From: Garry Christensen
To: Jerry Finlinson
Date: 3/31/2004 5:07 PM
Subject: Re: Burner and Windbox temps 31mar04

Jim Knapp and I went out Wednesday 31mar04 2pm and measured the windbox and burner temperatures on U2.

Jerry Finlinson pointed out to us that there was an as built change to the burner total and static pressure signal take-off fittings depending if the burner was a CW or CCW design. Please see attached PDF of Air Monitor drawing W50633BC REV 1 which addresses this issue.

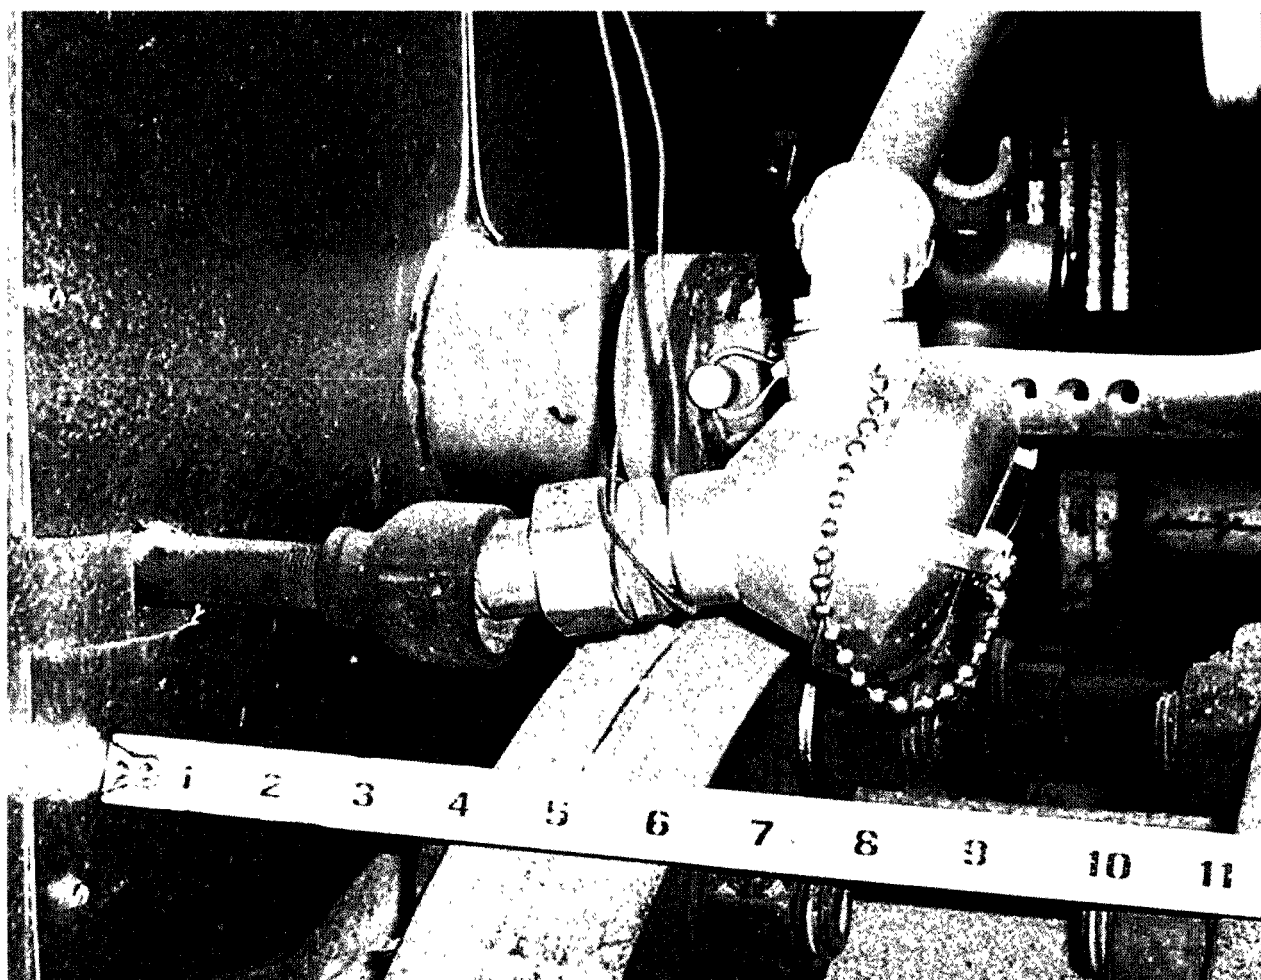
>>> "Tom Shults" <Tom@advancedburner.com> 3/24/2006 9:01:40 AM >>>
Good morning Jerry. In reviewing the TC length, I noticed that the nipple welded to the burner front extends only 2 inches minimum according to our drg. If this is not adequate due to insulation or whatever, we could provide another nipple. Let me know what extra length you need, but make sure that if we extend that we don't hit something else with the TC head. I understand that the existing nipple has a coupling on it. So, we could just screw a nipple into this coupling and then add the bushing and the TC head (per my 3-15-06 email regarding the 1/8 inch TCs).

Pls let me know what you have, and what you need, so we can get the length correct.

We need 1/16 inch diameter TC's of length 60.25 and 103 & 9/16 inches. see DWG 10-4881. But we only need it with the 3/8 pipe nipple, which is different than your original drawing.

System:	<u>2SGB-FT-172 thru 219</u>	Date:	<u>4-15-08</u>
Description:	<u>U2 Burner Flowmeter IBAM</u>	Page:	<u>2 of 2</u>
By:	<u>Jerry Finlinson</u>

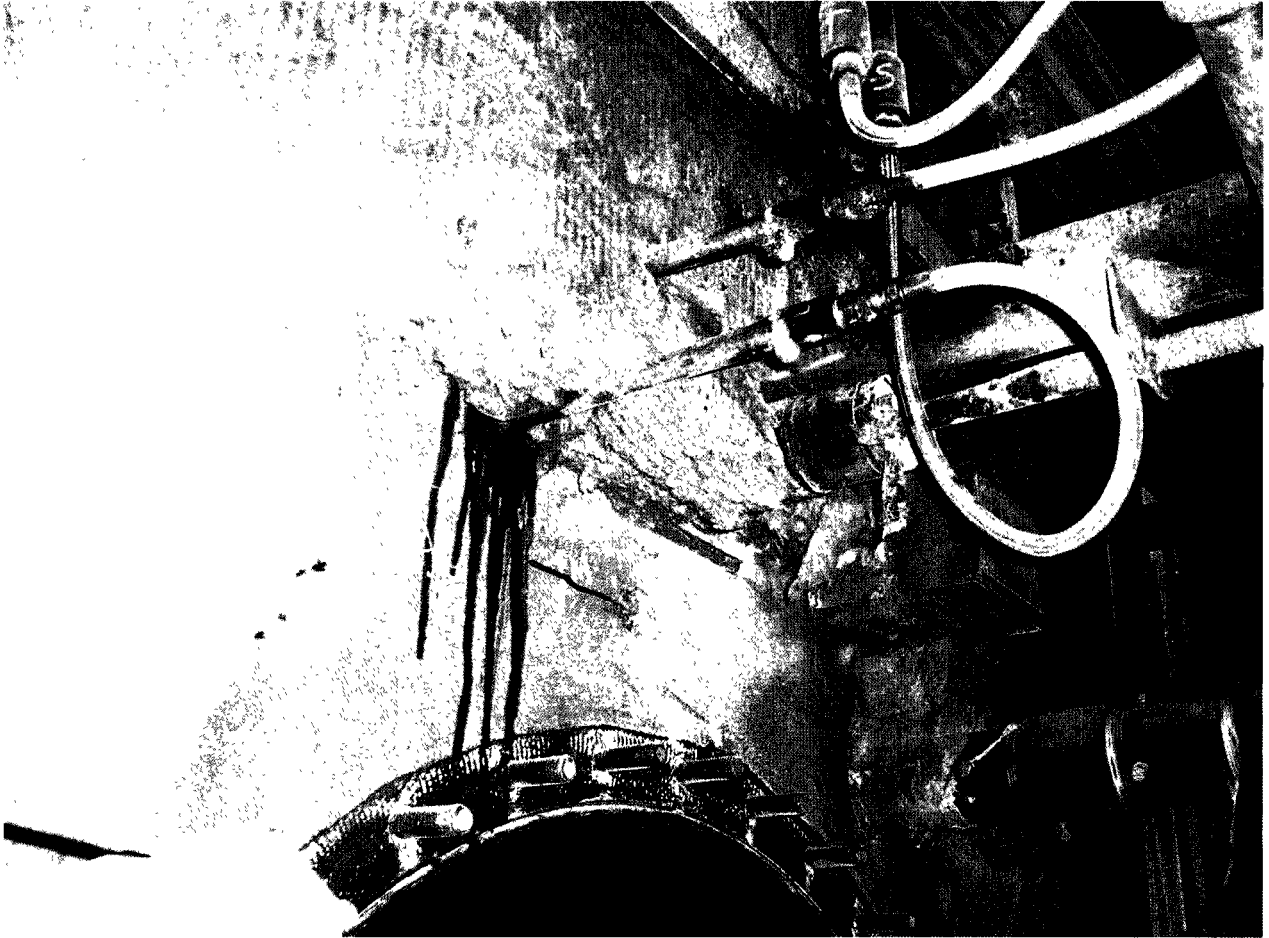
I&C is snooping the piping and flex lines outside the windbox. They are redoing the connections with the flex tubing using red RTV. 4 joints require weld repair.

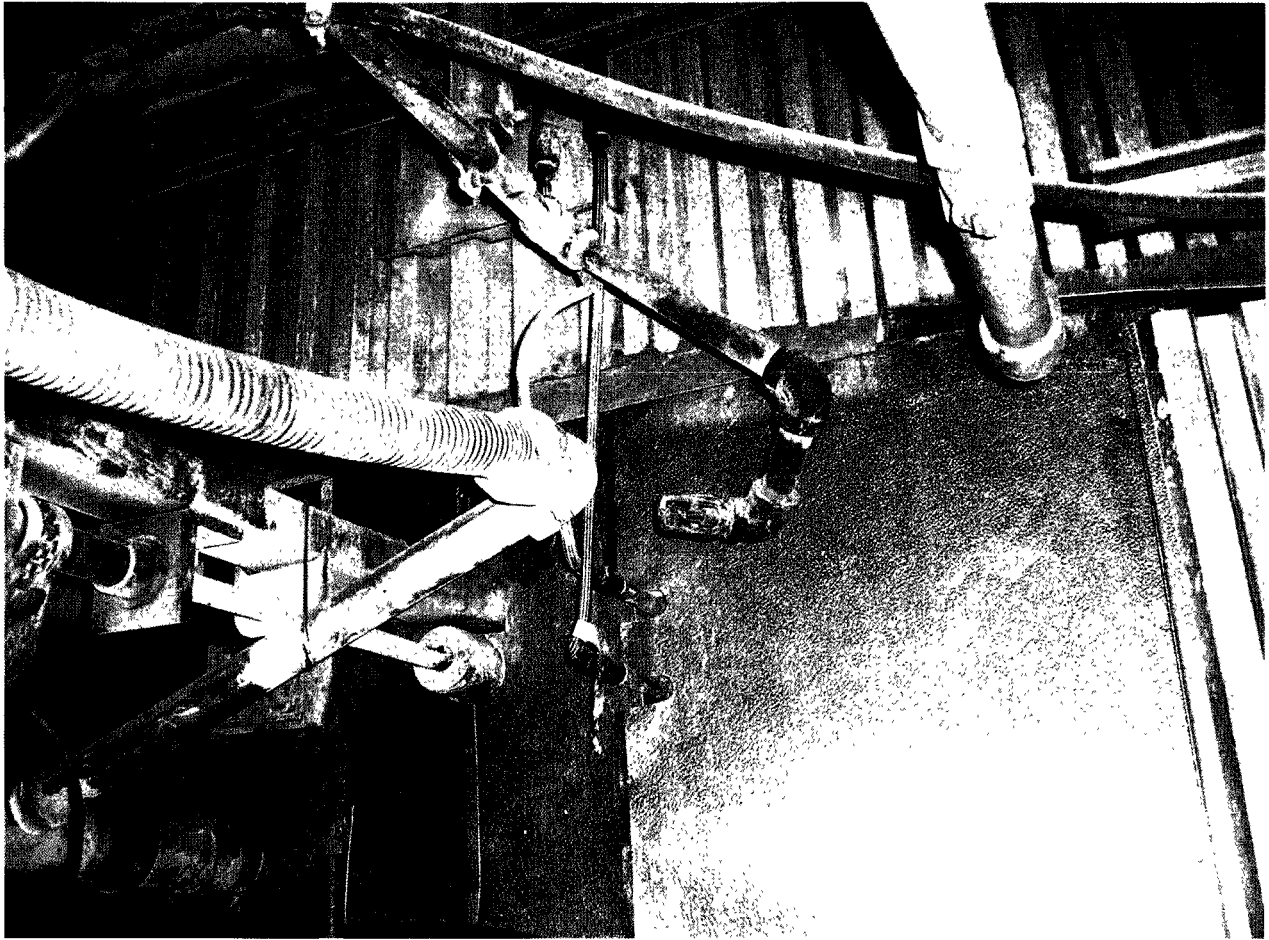
Please note in the attached photo that the stainless flex line on B4 burner IBAM is too short, it is stretched tight and kinked. Please have someone replace it with a longer one. The current one is about 24 inches. So if there were a 30 or 36, that would be good.

Jim Knapp can write a work order to do this work.
